December 31, 2002

- SUBJECT: Arkansas Nuclear One, Unit 2 Docket No. 50-368 License Amendment Request to Revise Various Technical Specifications and the Administrative Controls Section

Pursuant to 10CFR50.90, Entergy Operations, Inc. (Entergy) hereby requests the following amendment for Arkansas Nuclear One, Unit 2 (ANO-2): 1) reorganization of the ANO-2 Technical Specification (TS) Section 6.0 Administrative Controls; and 2) modification of various TS actions and surveillance requirements.

TABLE 3.3-6

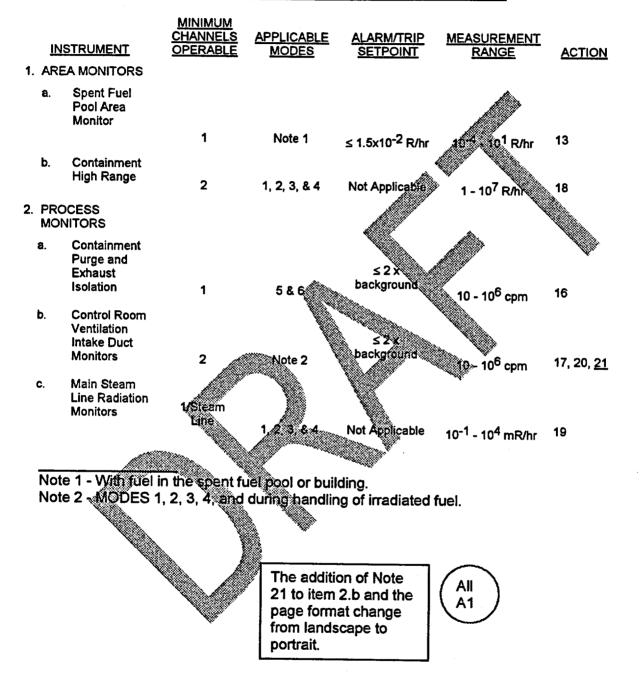
A new action 21 will be added and annotated in the ACTION column for item 2.b, Control Room Ventilation Intake Duct Monitors In addition the page format will be changed from landscape to portrait. See DOC A1.

Action 17 will be modified to be applicable in Modes 1, 2, 3, or 4 and a shutdown statement will be added. See DOC A1, M4, and M5. Actions 18 and 19 2) will be changed to direct that Special Reports be sent to the NRC. See DOC A6.

Action 20 will be modified to be applicable in Modes 1, 2, 3, or 4 and a shutdown statement will be added. See DOC M3, M4, and M5

A new Action 21 will be added which will be applicable during handling of irradiated fuel. See DOC M5

- ACTION 21 During handling of irradiated fuel with one or two channels inoperable, immediately place one OPERABLE CREVS train in the emergency recirculation mode or immediately suspend handling of irradiated fuel.

TABLE 4.3-3

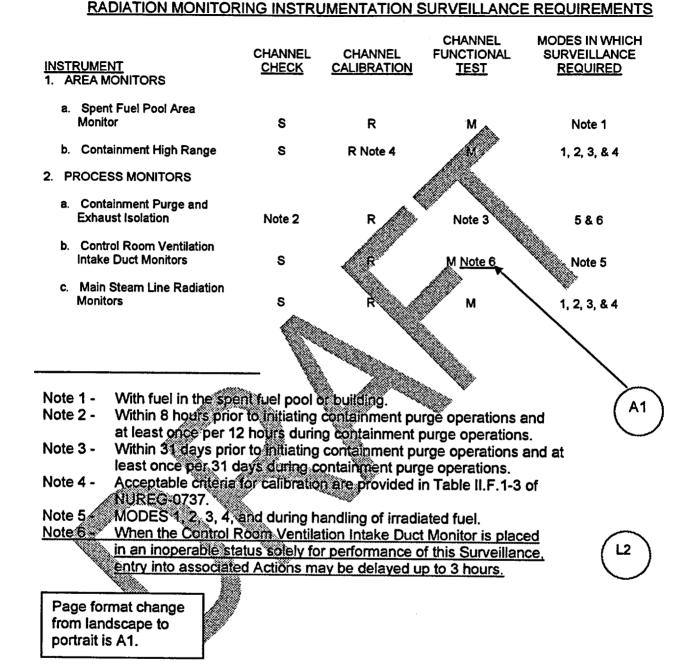
A new Note 6 will be added to item 2.b. The addition of the reference to Note 6 in the Channel Functional Test column and the change of the page format from landscape to portrait are administrative. See DOC A1. The addition of Note 6 is less restrictive. See DOC L2.

L2	It is proposed to add Note 6 to CTS Table 4.3-3. The note provides three (3) hour time period with the monitor inoperable to conduct the CHANNEL FUNCTIONAL TEST without entering the associated Actions. This allowance is based on an industry average time frame for conducting the test and the need to conduct the teat during conditions for which the monitor is normally required to be OPERABLE. When performing the channel functional test on the radiation monitors, the monitors' intended function of isolating the control room and starting the appropriate emergency ventilation system is demonstrated. Is there some justification topical report or something?		
L3	The requirements of CTS 3.7.6.1 will be revised to allow the control room boundary to be opened intermittently under administrative controls, and to allow both CREVS trains to be inoperable for 24 hours if due to a control room boundary inoperability. This condition is not allowed by the CTS, and would result in an entry into the requirements of LCO 3.0.3. Requiring entry into LCO 3.0.3 for this condition is excessive, as it does not provide sufficient time to attempt a repair. The proposed change is acceptable because of the low probability of a design basis accident during any given 24 hour period and because entry into the Condition is expected to be very infrequent. The allowance to have the control room boundary open Intermittently is acceptable as the administrative controls that must be implemented will ensure that the control room boundary can be rapidly closed when a need for control room isolation is indicated.

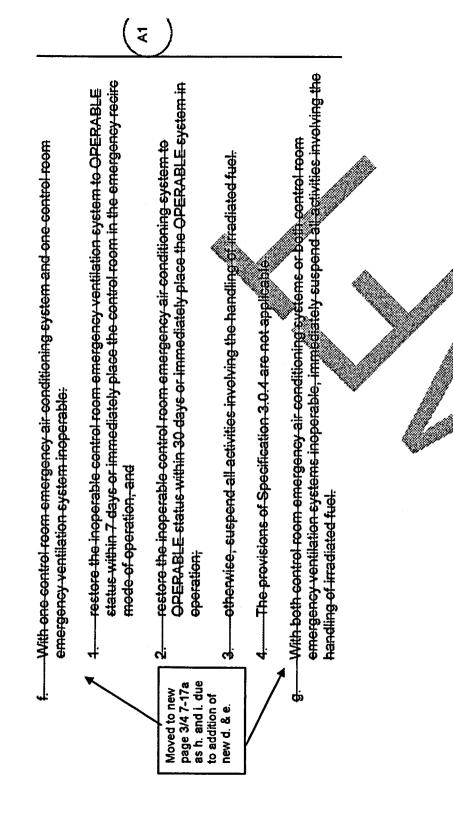
A new Note 1 and new Actions d. and e. will be added. See DOC A1, A7, and L3.

Note 1: The control room boundary may be opened intermittently under administrative controls.

6.3 UNIT STAFF QUALIFICATIONS

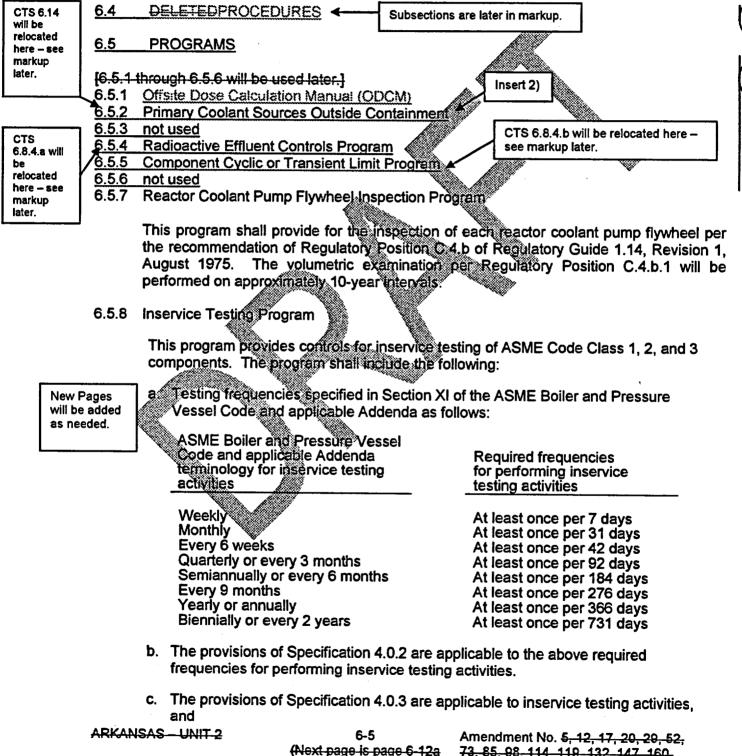
The proposed change makes minor preferred format changes and replaces the ANSI requirement that is referenced with a different ANS requirement. See DOS M7 and A1.

- M7
- 6.3.1 Each member of the unit staff shall meet or exceed the minimum qualifications of ANSI N18.1-1971ANS 3.1-1978 for comparable positions, except for (1) the designated radiation protection manager, who shall meet or exceed the minimum qualifications of Regulatory Guide 1.8, September 1975.
